6. Wales Subdivision; KPB File 2022-061

WALES SUBDIVISION

KPB File No.	2022-061
Plat Committee Meeting:	May 23, 2022
Applicant / Owner:	Charles Shenyer of Pateros, WA
Surveyor:	Steve Smith / Geovera LLC
General Location:	Tim Avenue, Sterling Highway, Shegota Loop, Happy Valley

STAFF REPORT

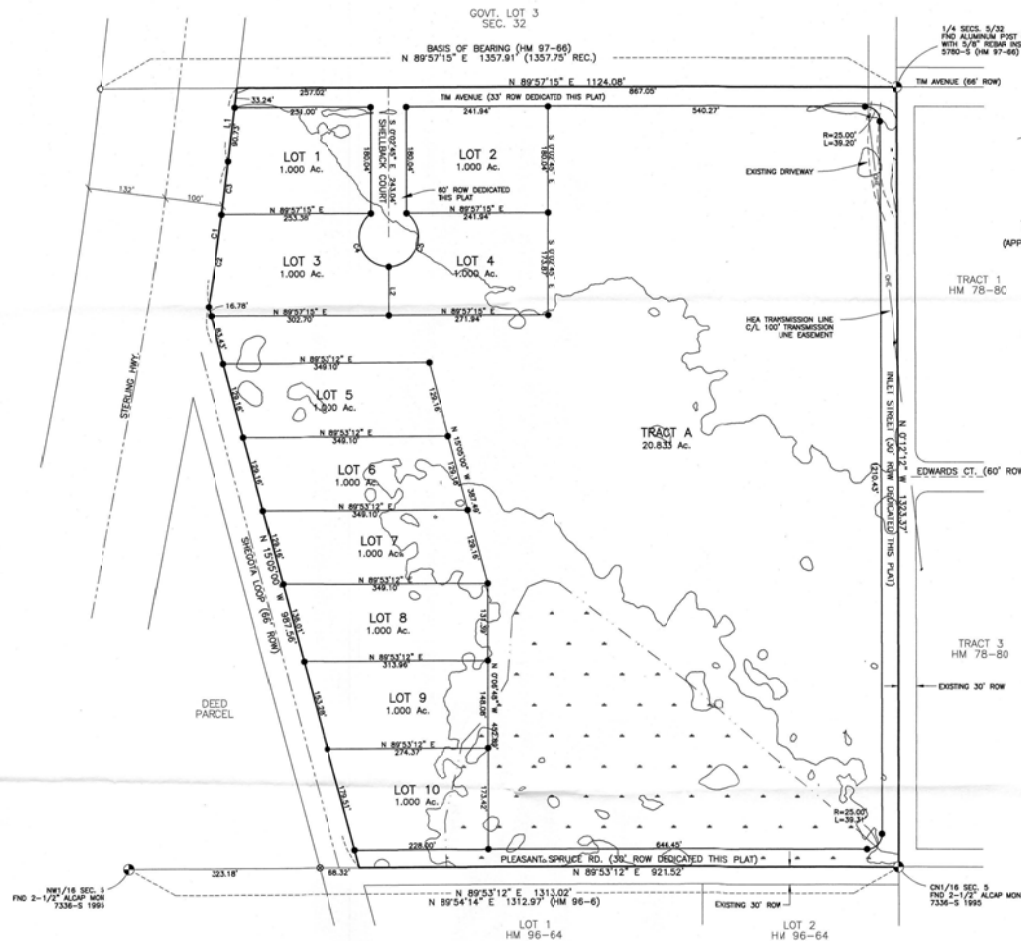
The State of Alaska DOT is the agency that would have to grant driveway permits to the Sterling Highway. The Kenai Peninsula Borough Roads Department would be the entity for driveways off Tim Avenue. Due to the close proximity of Shellback Circle to the intersection of Tim Avenue and the Sterling Highway, as well as the distance between Tim Avenue and Shegota Loop, the desire would be for all driveways for Lots 1 thru 4 to be issued from the proposed cul-de-sac. ***Staff recommends a plat note be added that states "Lots 1 thru 4 shall be limited to access from Shellback Circle."***

Inlet Street appears to have some possible encroachments within the dedication. The existing travel way goes around some of the encroachments and even with the additional dedication being given by this plat, goes slightly into this property. KPB Code Compliance/Road Department are aware of the possible encroachment issues. ***Staff recommends the owner of the proposed plat work with the land owners to resolve the encroachment issue. Resolutions may require realignment or the issuance of a driveway or access easement.***

Site Investigation: Low wet areas are present within the southeastern portion of this subdivision. The area is depicted and the correct plat notes are present. **Staff recommends** the wet areas be depicted on the final but are currently shown in color and must be in black and white on the final.

Staff recommends the plat committee review the design of Tract A and determine if this should be reviewed as a flag lot.

If it is determined that is a flag lot with the future possibility of being a dedicated right-of-way, **staff recommends 20 foot building setbacks be required for Lots 3, 4, and 5 in accordance with KPB 20.30.190(B) and 20.30.240, the setbacks be depicted and the following plat notes be added.**

- "Lots 3, 4 and 5 are subject to a 20 foot building setback for the portions adjoining the access area of Tract A."
- "No permanent structures or wastewater disposal is permitted within the panhandle portion of Tract A."

If it is determined that this should not be considered a flag lot and the plat committee does not wish to create additional setbacks **staff recommends the following plat note be placed on the plat "The access portion of Tract A may have possible limitations on future subdivision based on access issues, development trends in the area, or topography."**

The plat is proposing to dedicate 10 foot utility easements adjacent to all rights-of-way and increasing to 20 feet within 5 feet of all side lot lines. Due to the scale this may be difficult in some locations to clearly depict. There is currently a detail for the building setback. **Staff recommends the detail include the depiction of the utility easements to be granted by this plat and the plat note include "granted by this plat".**

- C. The location, width, and name of existing or platted streets and public ways, railroad rights-of-way, and other important features such as section lines or political subdivisions or municipal corporation boundaries abutting the subdivision;
Staff recommendation: *Depict and label the 33 section line easement north of the subdivision. Include a reference to the highway project map for this portion of the Highway.*

- F. The location, width and name of existing and platted streets and public ways, railroad rights-of-way, easements, and travel ways existing and proposed, within the subdivision;
Staff recommendation: *The KPB Addressing Officer approves the street name but the suffix must be corrected to Circle.*

- G. The status of adjacent lands within 100 feet of the proposed subdivision boundary or the land status across from any dedicated rights-of-way that adjoin the proposed subdivision boundary, including names of subdivisions, lot lines, block numbers, lot numbers, rights-of-way; or an indication that the adjacent land is not subdivided;
Staff recommendation: *Include labels for the lots located to the northeast, southeast, and southwest of the subdivision. Verify that the lot to the north is Government Lot 3 and not an aliquot description that can be listed as "Unsubdivided"*

Staff recommendation: *The acceptance only states the cul-de-sac. The name should be updated for the correct suffix and include all other right-of-ways being granted by this plat.*

- *"No access to state maintained rights-of-way permitted unless approved by the State of Alaska Department of Transportation."*
- *Roads must meet the design and construction standards established by the borough in order to be considered for certification and inclusion in the road maintenance program (KPB 14.06).*

TYPICAL 20' BUILDING SETBACK FROM STREET RIGHTS-OF-WAY (APPLIES TO ALL LOTS - SEE NOTE 3)

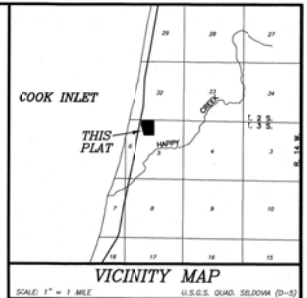
Staff would recommend the detail be slightly revised. Due to common misconceptions about locations of roads and where setbacks begin, some revisions and more information is recommended. Instead of labeling as 'EDGE ROW' it would be advised to change to "PROPERTY LINE" and then include another notation "Dedicated ROW" to show the relationship between the two.
